HISTORIC PRESERVATION COMMISSION

AUGUST 27, 2020

To: Historic Preservation Commission
From: Peter Hughes, Senior Planner
CC: Darryn Burich, Planning and Inspections Director
Kelly Brown, Administrative Specialist
Date: August 20, 2020
Subject: Major COA Request for 55 Shaw Road (COA-2020-00098)

To: Historic Preservation Commission
From: Peter Hughes, Senior Planner
CC: Darryn Burich, Planning and Inspections Director
Kelly Brown, Administrative Specialist
Date: August 20, 2020
Subject: Major COA Request for 41 Shaw Road (COA-2020-00099)

DRAWING NAME:
SITE PLAN

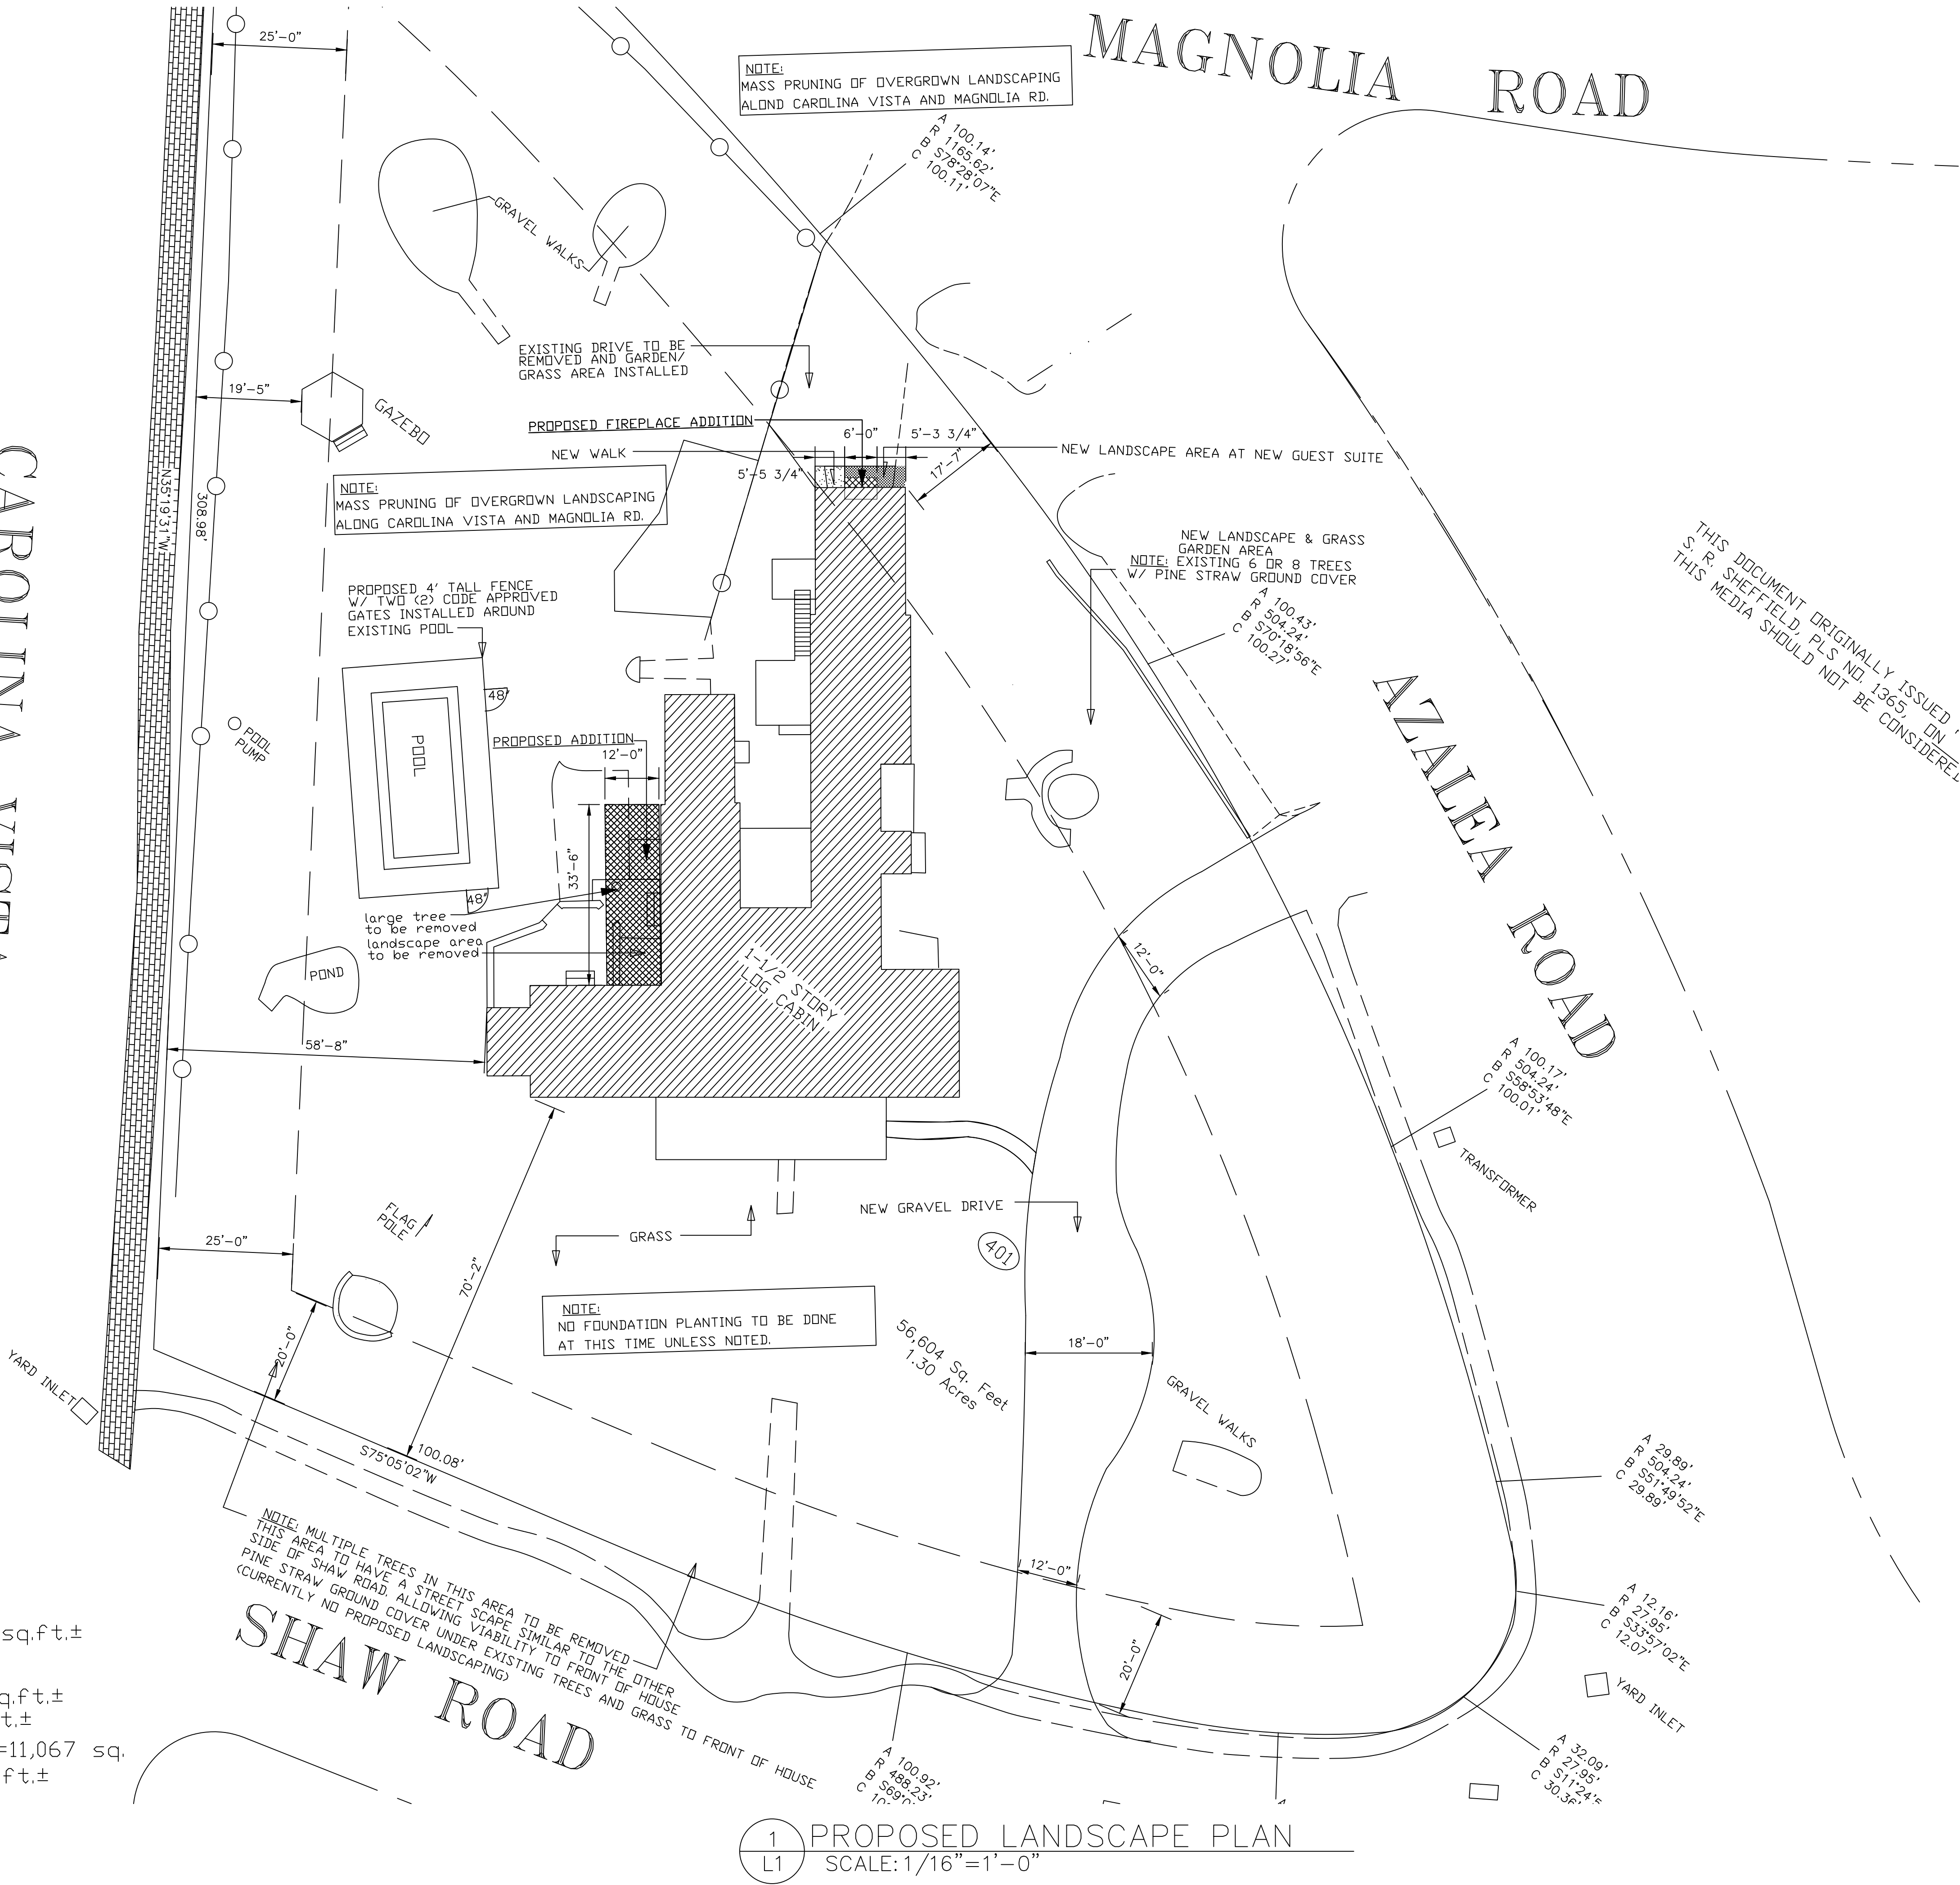
It is unclear from the submitted material whether existing large trees were incorporated into the plans for the addition and driveway reconfiguration.

2 PROPOSED LEFT ELEVATION
A2 SCALE: 3/16"=1'-0"

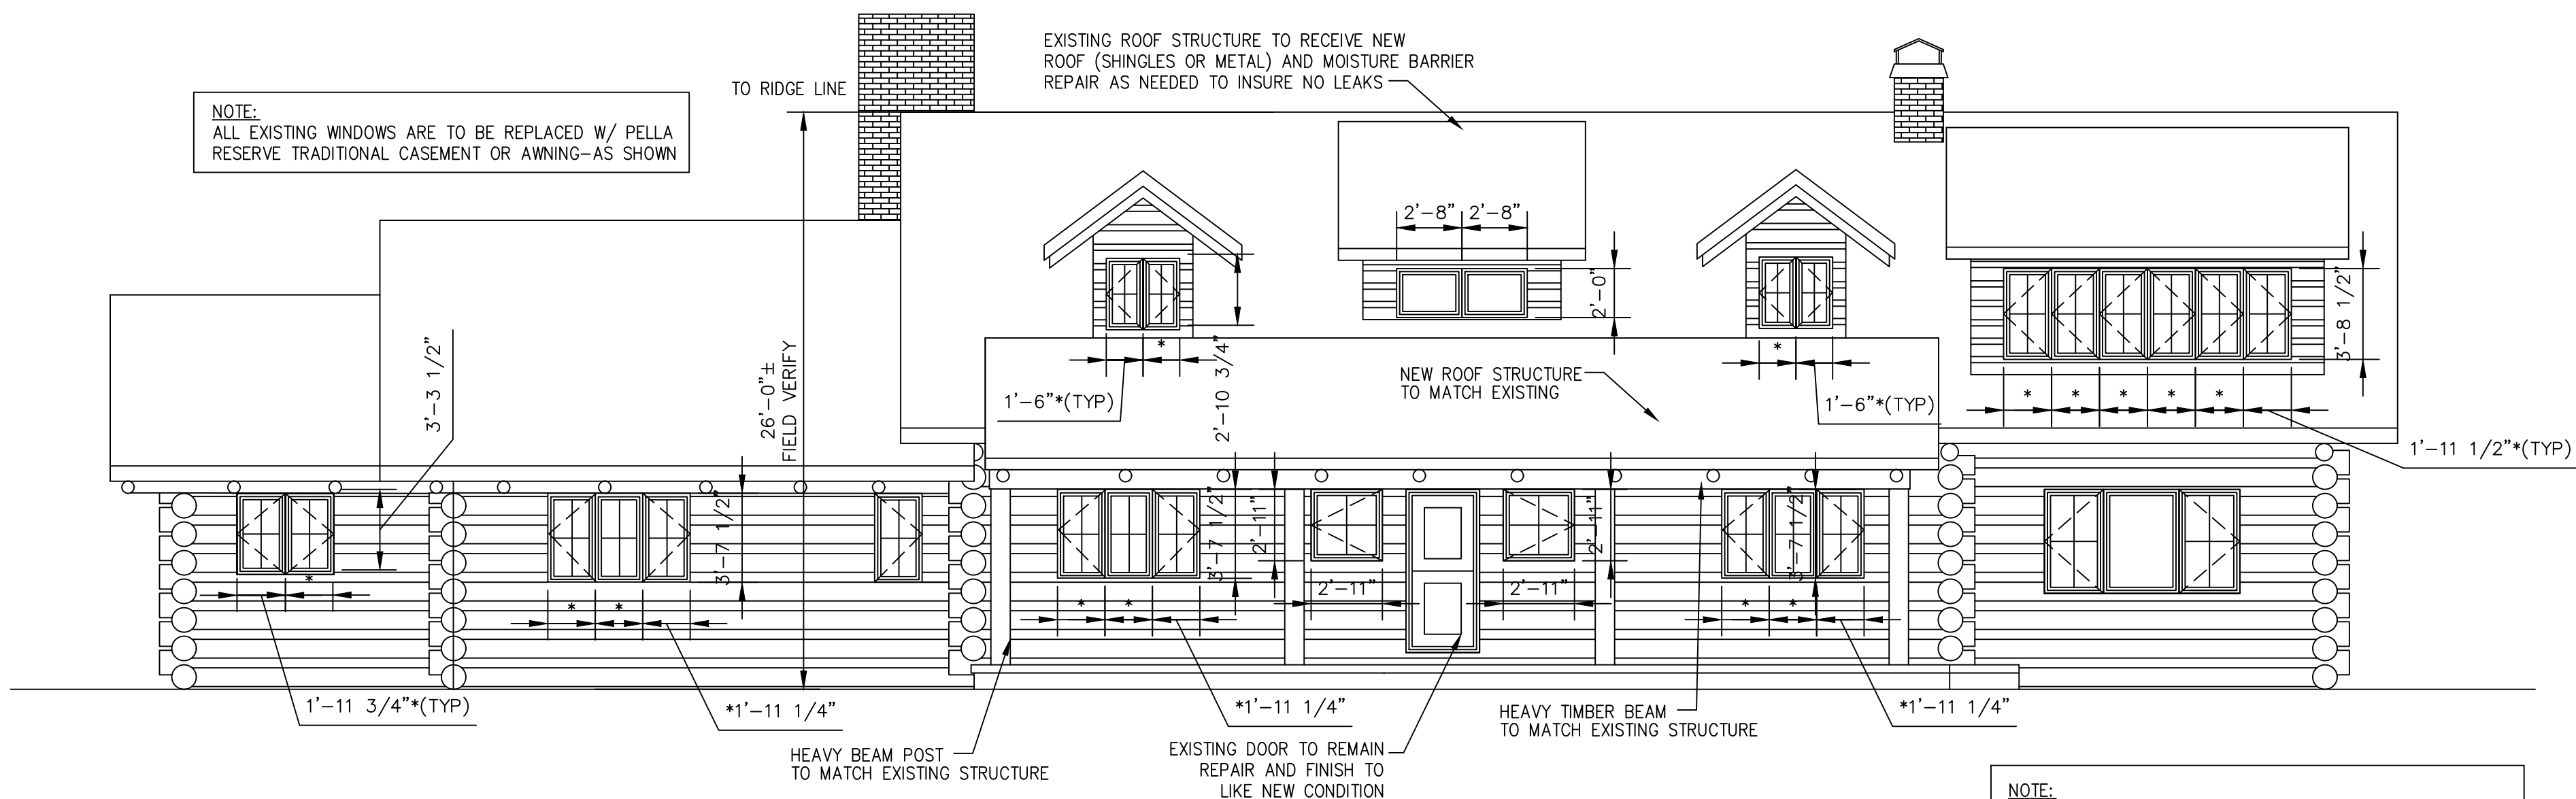
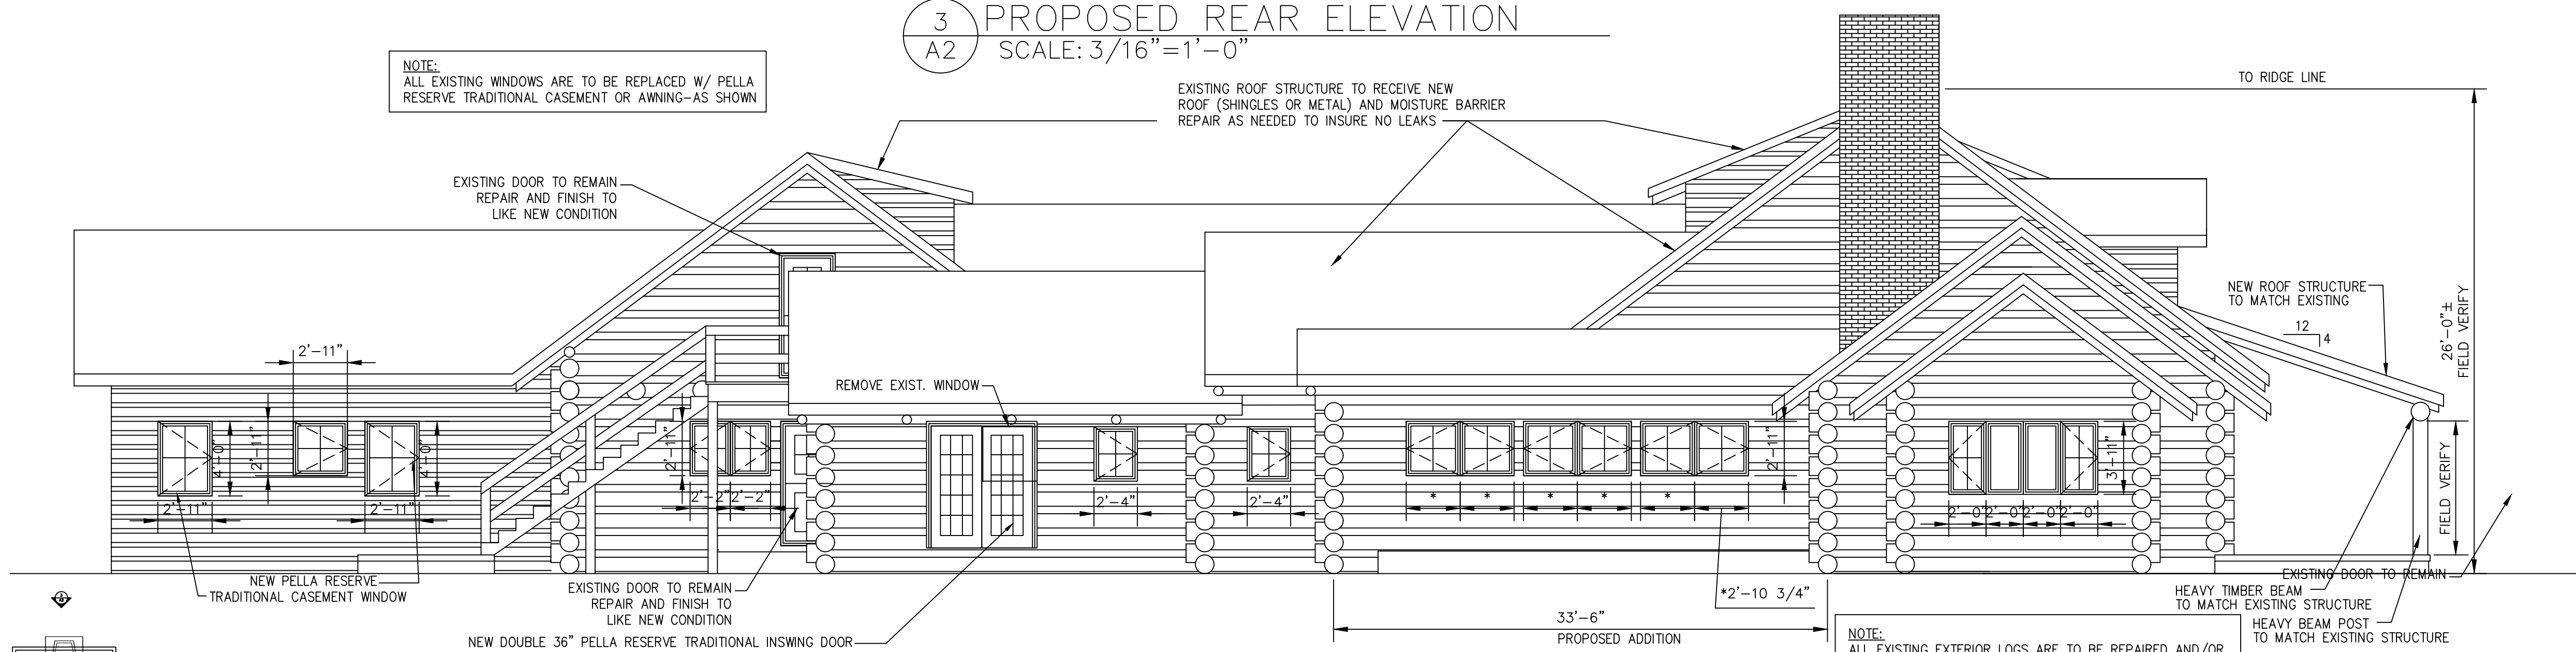
One window opening is proposed to be modified from a window to a door on the left elevation. The proposed door is compatible with other doors on the primary structure and the proposed modification should not compromise the architectural character of the structure.
